## Maestro

# TECHNICAI

THROTTLE CABLE SEIZURE

Fig. 3/1

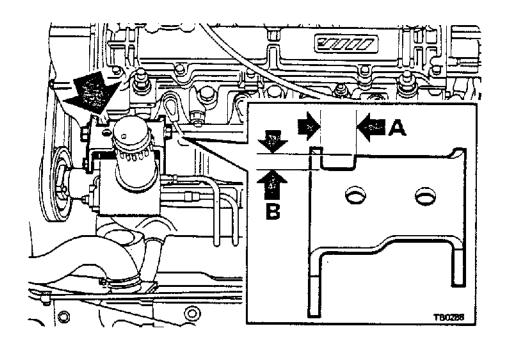
p.a.s. pump belt cannot be adjusted correctly.

p.a.s. bracket fouls cam belt cover bracket when at limit of adjustment

Modified bracket introduced on production at vin 486707 (Maestro) and 379553 (Montego).

On earlier vehicles in service, the bracket can be modified by cutting a recess to the dimensions shown in the illustration.

Dimension "A" = 25 mm

Dimension "B" = 8 mm

Fig. 4/1

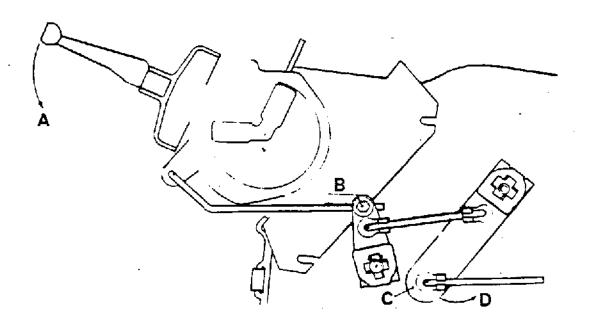
Heater output inadequate

incorrect adjustment of controls

- Remove fuse paner beneath steering wheel.
- Move heater "blend" control lever 'A' on fascia to maximum heat position.
- 3 Loosen bolt 'B'.
- 4 With blend control lever as far downward as it will naturally travel, rotate lever 'C' in direction of arrow 'D' as far as it will naturally travel
- 5 With levers 'A' and 'C' held in these positions, re-tighten bolt 'B'.
- 6 Check that blend fever 'A' now stays in the maximum heat detent position.

Move blend lever up and down a few times and then return it to the maximum heat position. If the lever now engages in the maximum heat detent position, the increased effort required to disengage it should be detectable

- 7 Close all centre vents, set distribution control to "defrost". Select maximum fan speed and check that blend lever remains in maximum heat position. If not, switch fan off and repeat procedure from step 2.
- 8 Replace fuse panel.
- 9 Confirm that heater performance is now satisfactory
